ADDENDUM

NO. 1

PROJECT NAME: Early Learner's Academy 2

ADDENDUM DATE: June 19, 2025

1 MASTER PLAN - DEEP FOUNDATION ELEMENTS
S1.01 1" = 20'-0"

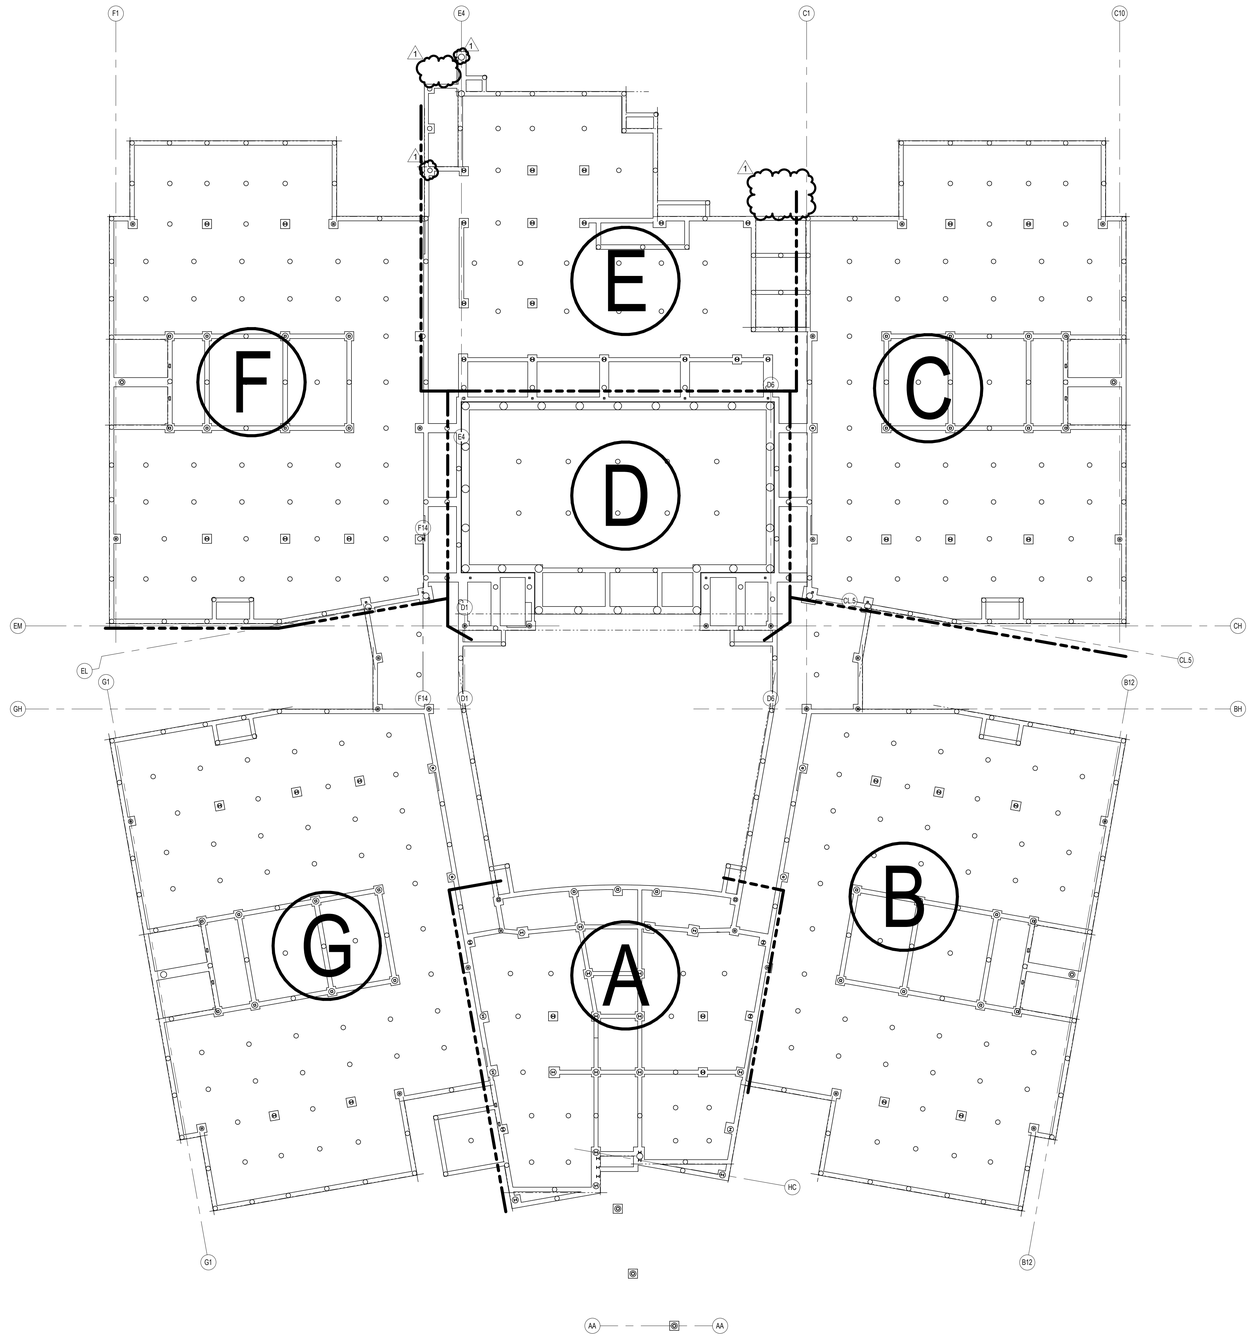
AD No 1, Struct Item 1: To the Drawings, Sheet S1.01, "MASTER PLAN - DEEP FOUNDATION ELEMENTS"
Revisions and clarifications as follows:

1) HSS5x5x1/4 column along gridline E2 removed.
2) W12x72 column along gridline E4 removed.
3) Removed hinge slabs erroneously drawn on sheet, see S1.02 "MASTER PLAN - FOUNDATIONS" for all hinge slab information.

1 MASTER PLAN - FOUNDATION
S1.02 1" = 20'-0"

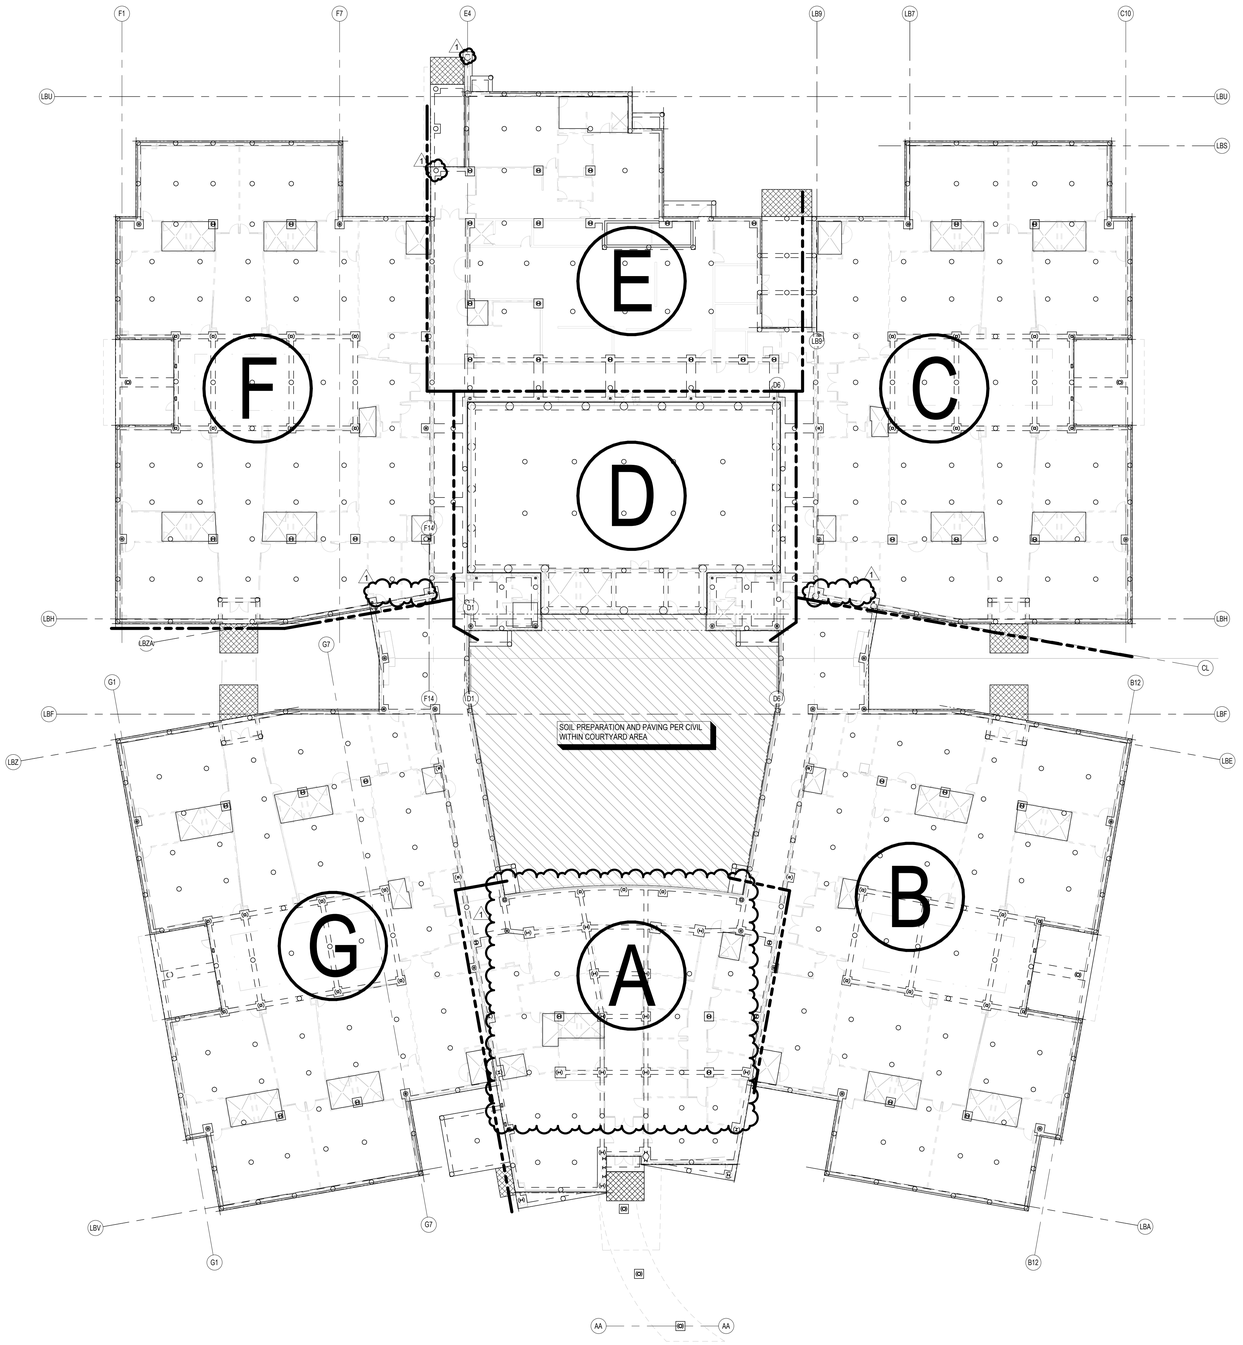
AD No 1, Struct Item 2: To the Drawings, Sheet S1.02, "MASTER PLAN - FOUNDATION"
Revisions and clarifications as follows:

1) HSS5x5x1/4 column along gridline E2 removed.
2) W12x72 column along gridline E4 removed.
3) Removed lateral brace frame graphics and elevation tags from this sheet, see S6.01 through S6.07 "ROOF FRAMING PLANS" for all lateral bracing locations.

1 MASTER PLAN - ROOF FRAMING PLAN
S1.03 1" = 20'-0"

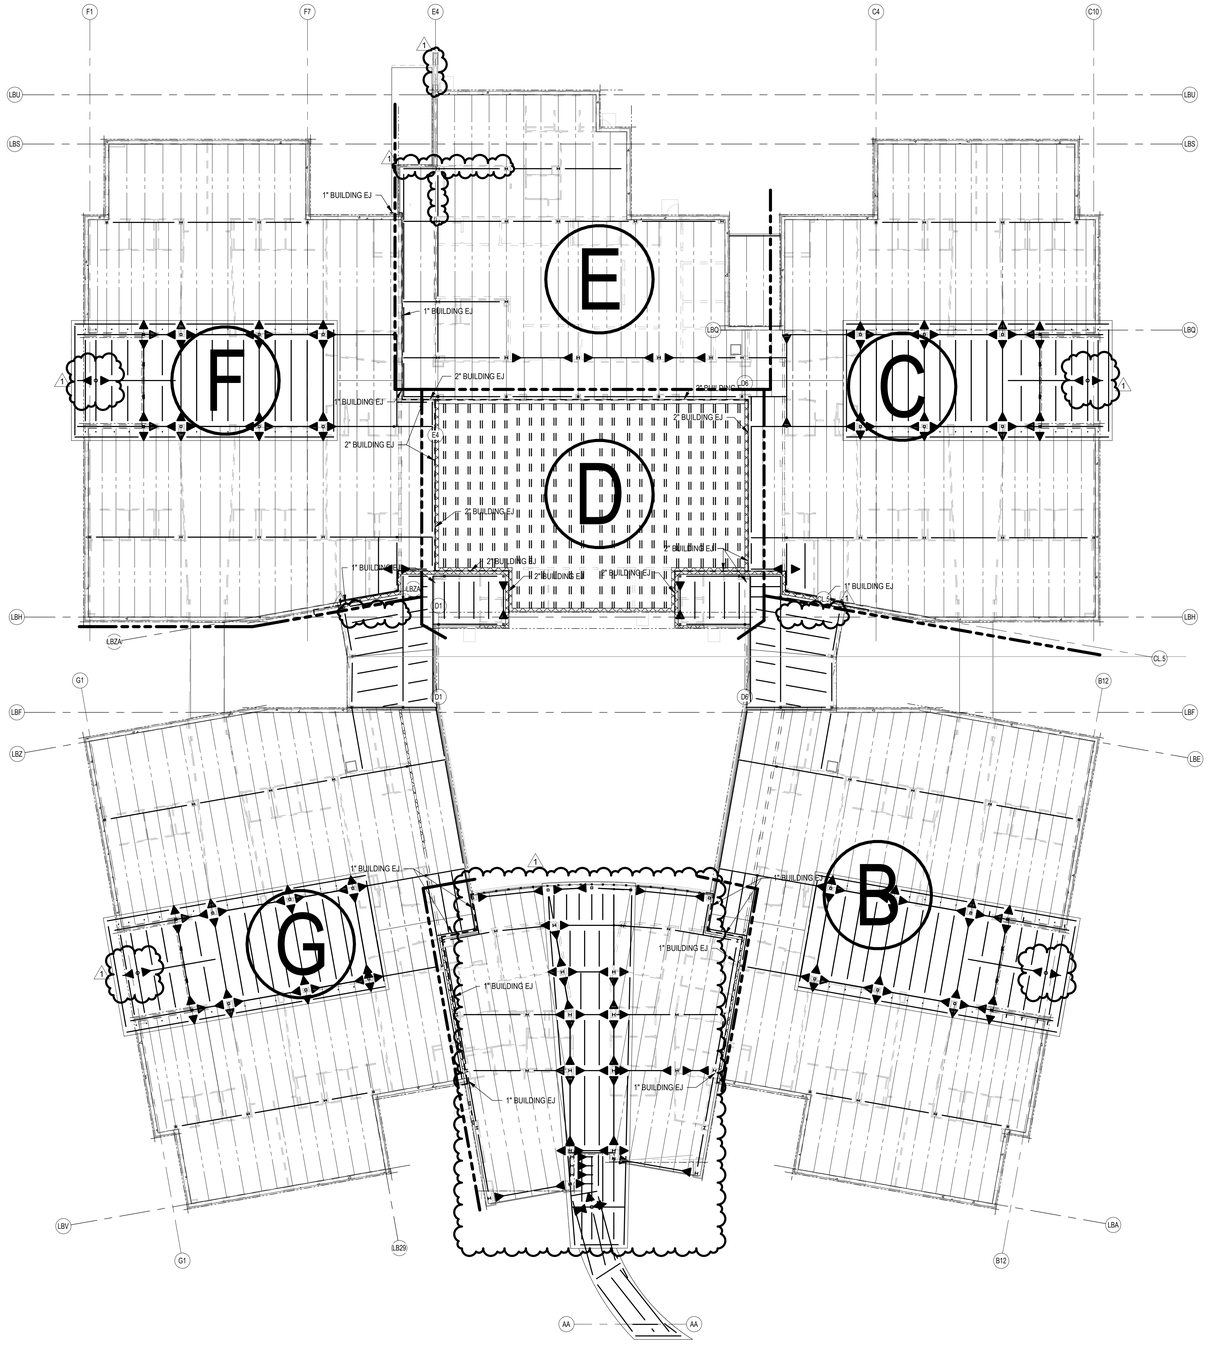
AD No 1, Struct Item 3: To the Drawings, Sheet S1.03, "MASTER PLAN - ROOF FRAMING"
Revisions and clarifications as follows:

1) HSS5x5x1/4 column along gridline E2 removed. W14x22 and W1626 beams along gridline EA replaced with cantilevering W24x55 beam. 12k3 joist replaced with W18x35 beam. Column connections adjusted to accommodate new beam configuration.
2) W12x72 column and HSS12x10x3/8 beams along gridline E4 removed and replaced with ICF wall.
3) Removed lateral brace frame graphics and elevation tags from this sheet, see S6.01 through S6.07 "ROOF FRAMING PLANS" for all lateral bracing locations.

1 DEEP FOUNDATION ELEMENTS PLAN - AREA B
S2.02 1/8" = 1'-0"

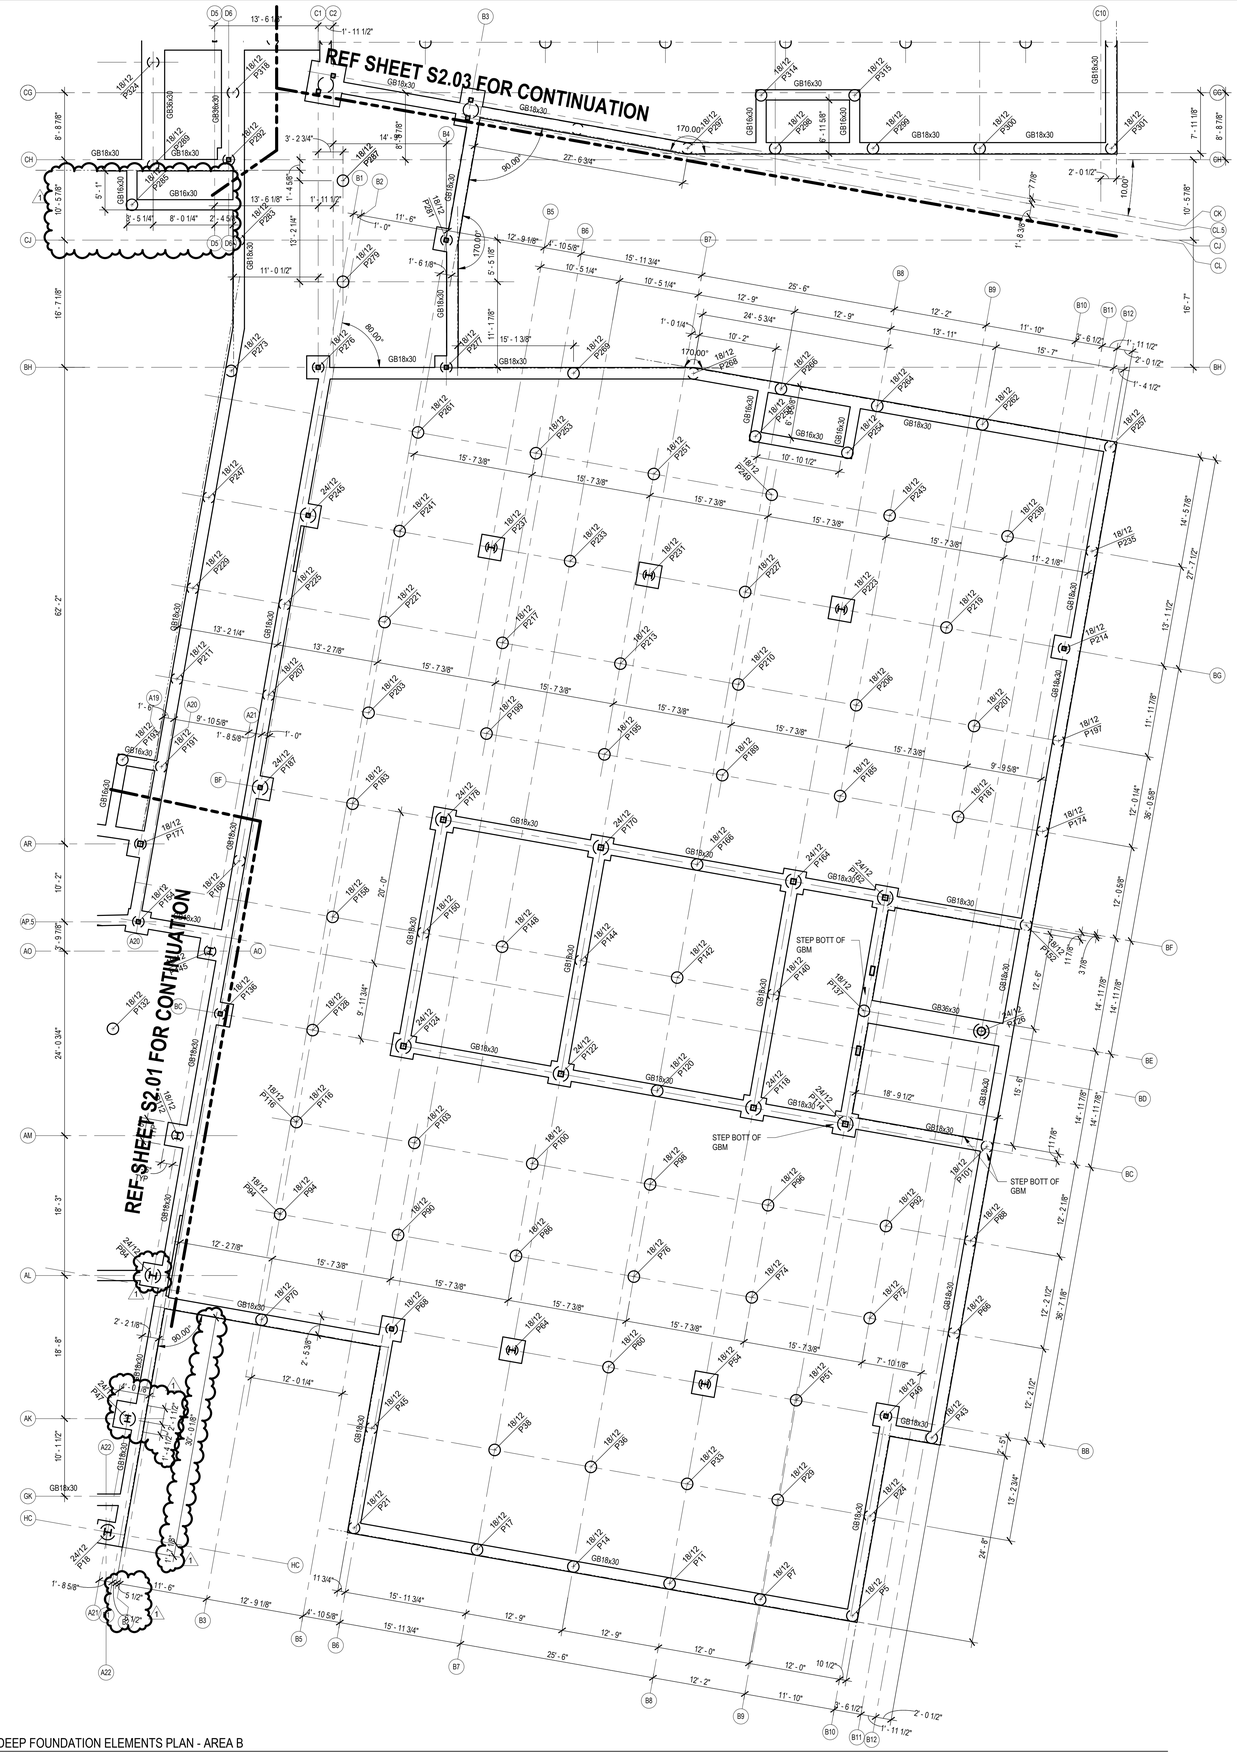
AD No 1, Struct Item 5: To the Drawings, Sheet S2.02, "DEEP FOUNDATION ELEMENTS PLAN - AREA B"
Revisions and clarifications as follows:

1 DEEP FOUNDATION ELEMENTS PLAN - AREA G
S2.07 1/8" = 1'-0"

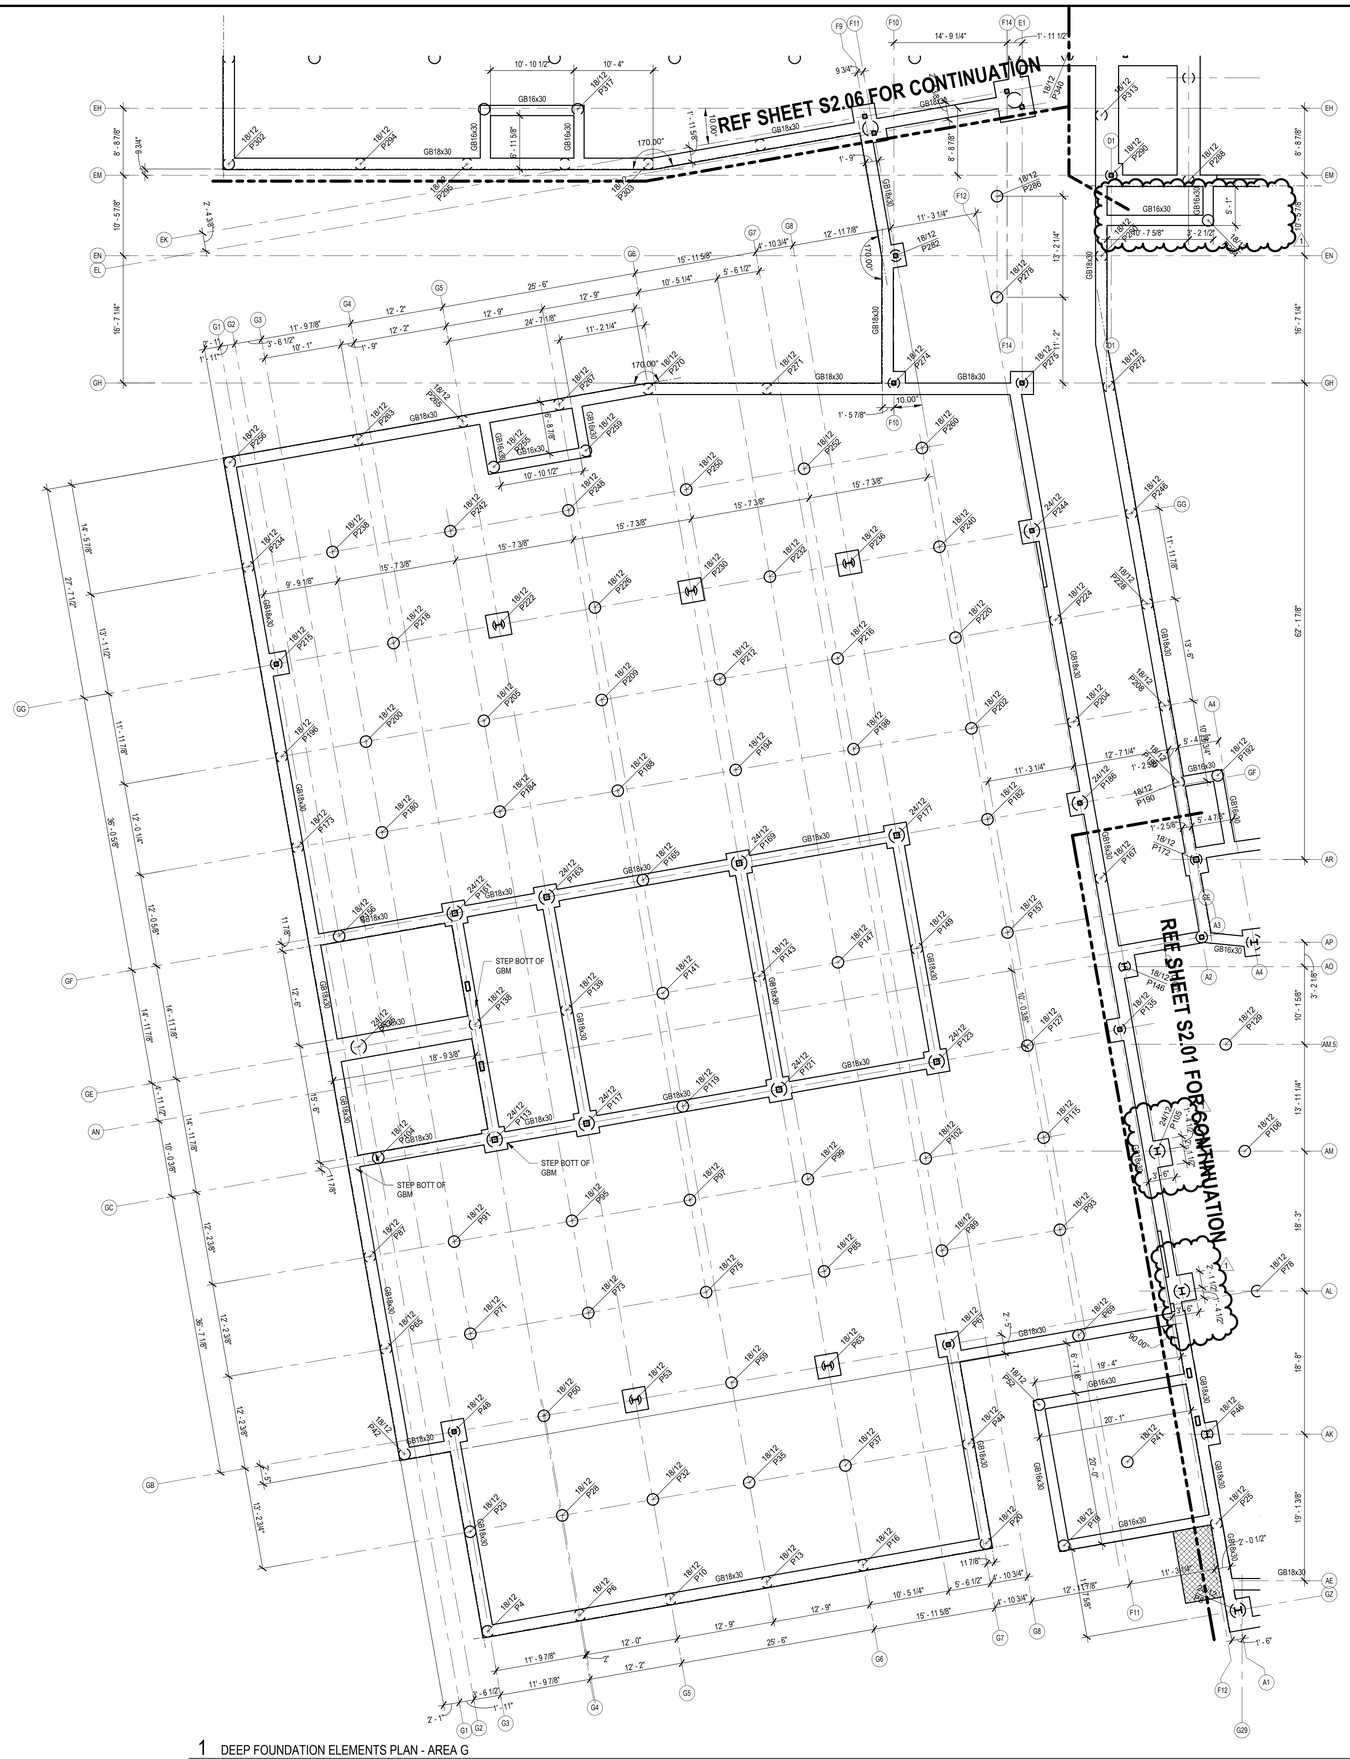
AD No 1, Struct Item 9: To the Drawings, Sheet S2.07, "DEEP FOUNDATION ELEMENTS PLAN - AREA G"
Revisions and clarifications as follows:

1 FOUNDATION PLAN - AREA A

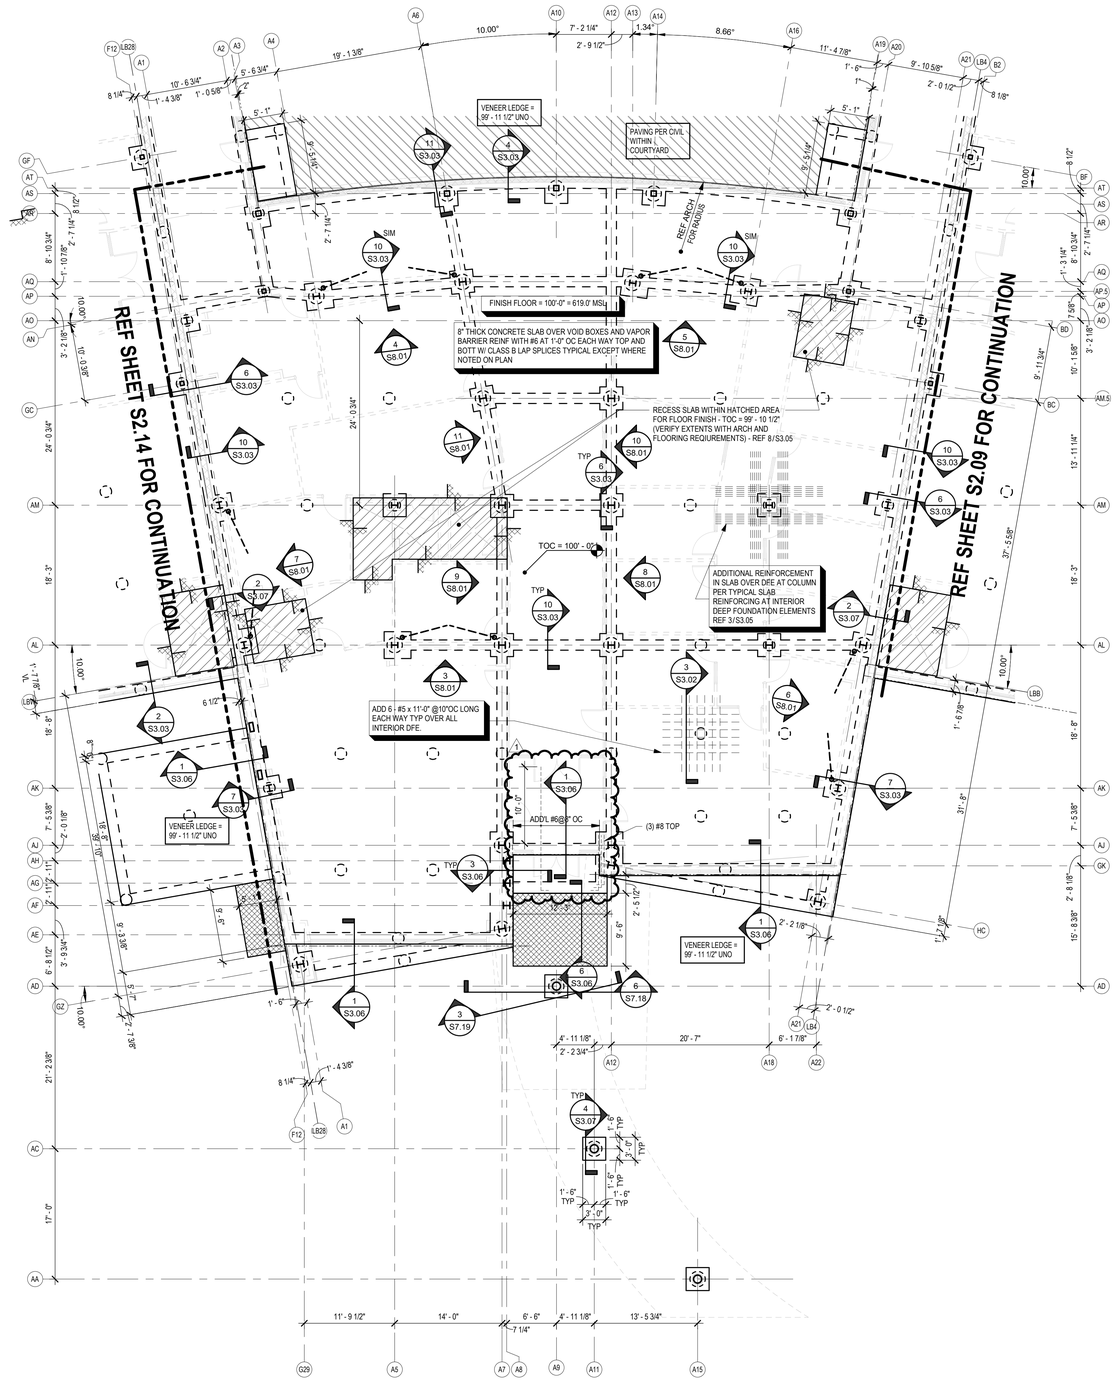
AD No 1, Struct Item 10: To the Drawings, Sheet S2.08, "FOUNDATION PLAN - AREA A"
Revisions and clarifications as follows:
1) Rebar details added.
2) Additional dimensions included for clarity.
